From: [Coleman Sadler](#)
To: [Joshua Gauthier](#)
Cc: [Kenneth Akerenwi Seh](#); [Aileen Stevens](#); [Candace Bryks](#); [Rebekka Lindskoog](#); [Daniel Leonard](#); [Don Plenderleith](#); [Patrick Cove](#); [Tyree Mullaney](#); [Wendy Bidwell](#)
Subject: Re: HREDP - Stockpile Area 1 Sump Water - Means of Disposal
Date: Wednesday, October 25, 2023 8:17:24 AM
Attachments: [image001.png](#)

Subject: HREDP - Stockpile Area 1 Sump Water - Means of Disposal

A screenshot from the GNWT Atlas website has been attached for reference. The areas in purple represent GNWT properties, while yellow represents the Town of Hay River.

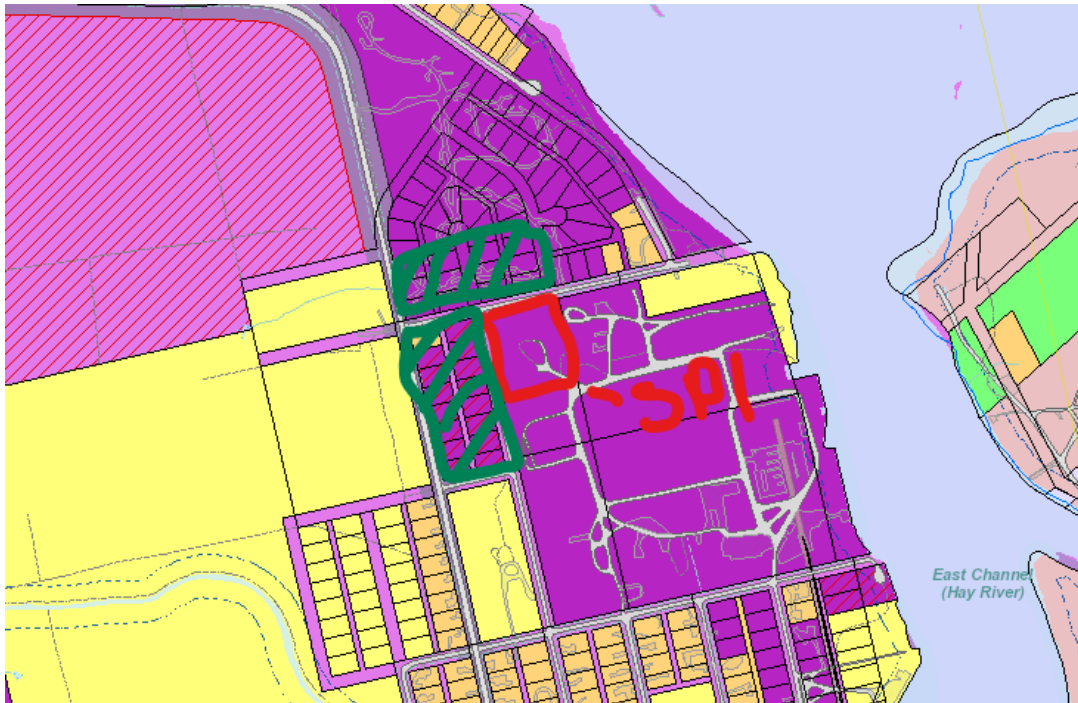
The project team has been discussing the means of disposal for the sump water and was hoping to discharge to the vegetated area immediately west of Stockpile Area 1. The Area north of Stockpile 1 is also being considered if the western area is unable to absorb the water.

We've added a comparison with the GNWT Effluent Discharge Criteria for sewage systems as reference. As the analytes are below GNWT Effluent Discharge Criteria (with the exception of TSS), do you see any concerns with discharging the water onto the aforementioned locations? Also what measures would you need implemented for this to take place?

Yes, we were comparing the sump results to the “Process Effluent Discharged to Municipal Systems” you’ve linked here as a reference. The CCME Water Quality Guidelines for the Protection of Aquatic Life were included based on contract wording, but wouldn’t be considered applicable in this case based on intended means of discharge.

We collected an additional sump water sample on October 21 and will get the results this week. Will send you the results once received. As of yesterday, the sump had about 2” of surficial ice. Based on the geometry of the sump (i.e., shallow) it would be impractical to pump out this season. It seems the path forward will have to be leaving the sump in place and reassessing during/after freshet.

Thank for sending the weekly analytical results of the sump water within Stockpile Area 1. My apologies in the late response. The weekly analytical report showed several outlined exceedances in reference to the CCME Aquatic Water Quality Guidelines. When you are referencing the Municipal Effluent Criteria, are you referring to the standards for [Process Effluent Discharged to Municipal Systems](#)? My recommendation currently is to leave the water within the containment area until it meets criteria or dissipates further as outlined in prior monitoring [documents](#). The sump water is likely frozen at this point anyways and does not impede on equipment or access to my knowledge but please let me know if this is ultimately your direction you would like to take with pooled water in sump area #1 in the spring.

Do you know if there will be another weekly analysis report or was this the last one for the season? In terms of the erosion and sediment control plan, it states that passive dewatering at the temporary storage sites is the main method of removing water from containment areas. If this is not working and you would like to discharge, just summarize your plans to mitigate any erosion from occurring during the process (i.e. clean rock diffuser, low pressure hose system, etc.) and we can go from there.
